V2500 Propulsion System — Nacelle

SERVICE BULLETIN

NACELLE - POWER PLANT - EEC COOLING -
REMOVAL OF

V2500-NAC-71-0069
Page 1 of 18

Removal of EEC Outlet Assembly
Figure 2

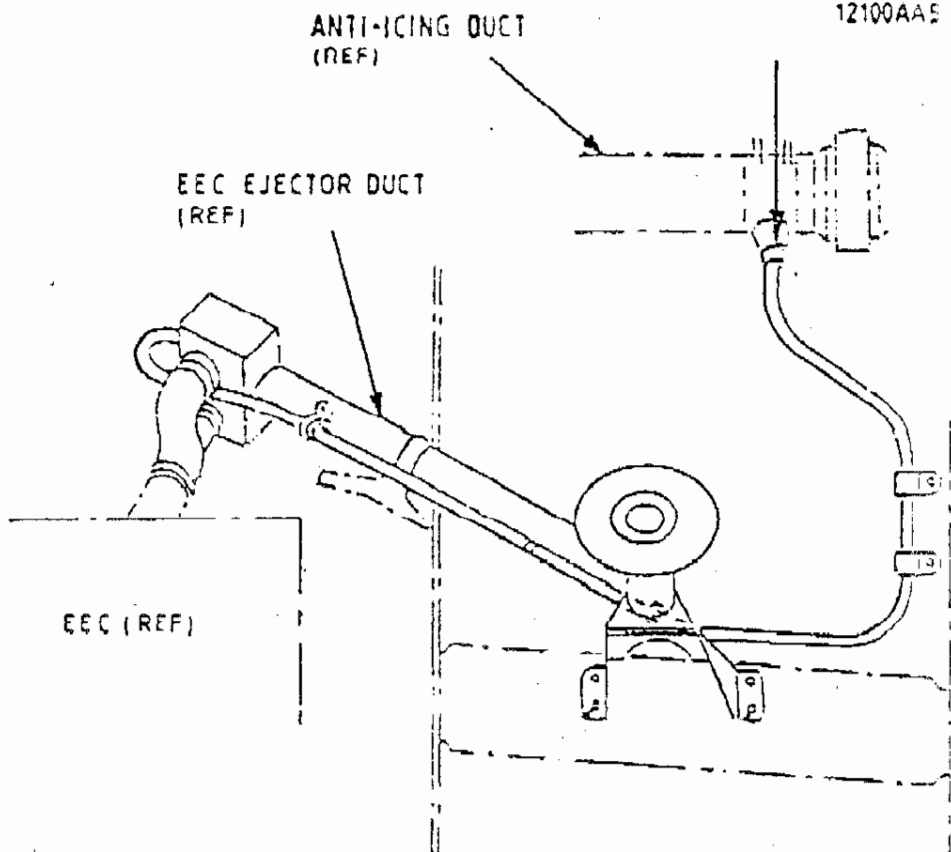
The EEC cooling inlet assembly and outlet assembly with associated pipes, clips, bolts, nuts, washers, and support bracket are removed from the engine fan case/fan cowl door. Blanks are bolted to the inlet and outlet holes on the fan cowl door and a blank is installed to the anti-icing duct. (Refer to Figure 2.)

- (1) Remove the EEC cooling ejector duct with instructions in V2500 Aircraft Maintenance Manual, Task 75-25-49-000-010. Discard all parts removed by this task.
- (2) Remove the EEC cooling flexible hoses with instructions in V2500 Aircraft Maintenance Manual, Task 75-28-48-000-010. Discard all parts removed by this task.
- (3) Remove the EEC cooling inlet duct with instructions in the V2500 Aircraft Maintenance Manual, Task 75-28-49-000-011. Discard all parts removed by this task except 17 (Bolt), 18 (Washer), and 19 (Nut). Install these items back to the engine flange. Torque to 100 lb-in. (11.3 N.m).
- (4) Remove the MS21902-55 union from the anti-icing duct and install a 740-5141-501 blank with a 12100AA5 seal in its place. Torque to 135-145 lb-in. (15.25-16.38 N.m).

NOTE: REFER TO THE V2500 AIRCRAFT MAINTENANCE MANUAL SECTION 75-28-49 FOR REMOVAL OF THE EEC EJECTOR DUCT.

REMOVE MS21902-SS UNION
INSTALL 740-5141-501 BLANK
12100AA5 SEAL

Installation of Blanks-Fan Cowl Door
Figure 3

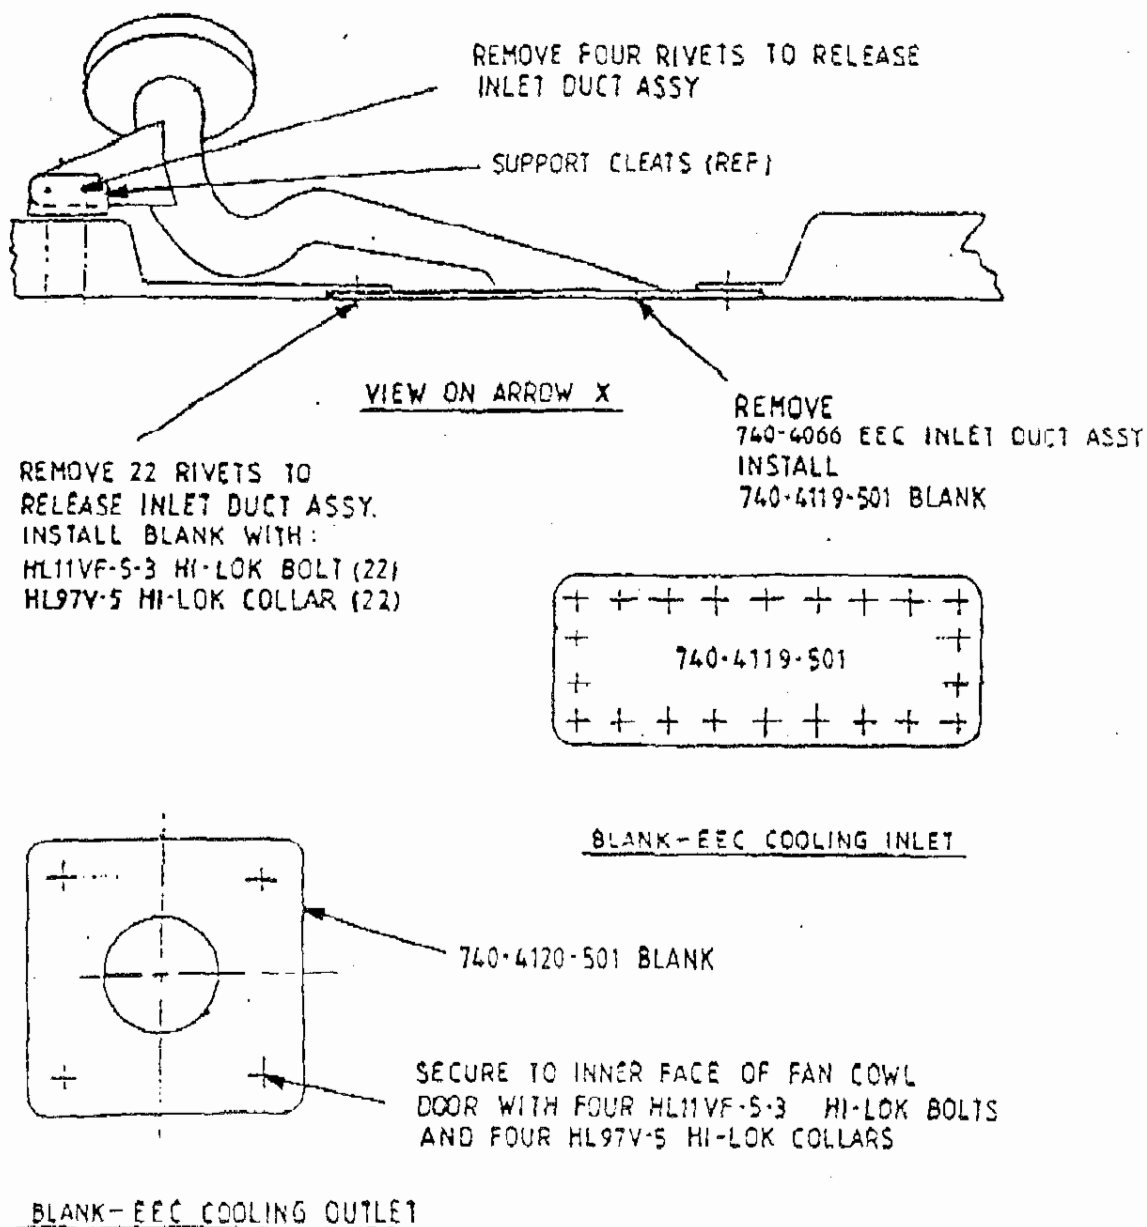
- (5) Remove 22 rivets to release the 740-4066 inlet duct assembly from the 740-4002 R.H. fan cowl door. Remove four rivets to release the inlet duct assembly from the support ducts. (Refer to Figure 3.) Discard the inlet duct assembly.
- (6) Hold the 740-4120-501 blank to the inner face of the 740-4002 R.H. fan cowl door at the EEC outlet (the center front of the blank to fill the outlet hole). Drill four holes 0.165 inches (4.20 mm) diameter into the fan cowl door from the blank. Remove any burrs from the holes.

- (7) Countersink the external face of the fan cowl door 100° to a depth of between 0.045 to 0.047 inches (1.14 to 1.19 mm).

- (8) Clean the mating faces of the 740-4119-501 and 740-4120-501 blanks with 1,1,1, trichloroethane.
- (9) Apply PL32 Hylomar to the face of the 740-4120-501 blank and install to the 740-4002 fan cowl door with four HL11VF-5-3 Hi-Lok bolts and four HL97V-5 Hi-Lok collars. Remove any excess Hylomar.

- (10) Seal any gaps on the outer face with 93-006 filler.
- (11) Apply PL32 Hylomar to the face of the 740-4119-501 blank and install to the 740-4002 fan cowl door with 22 HL11VF-5-3 Hi-Lok bolts and 22 HL97V-5 Hi-Lok collars. Remove any excess Hylomar with a clean rag.
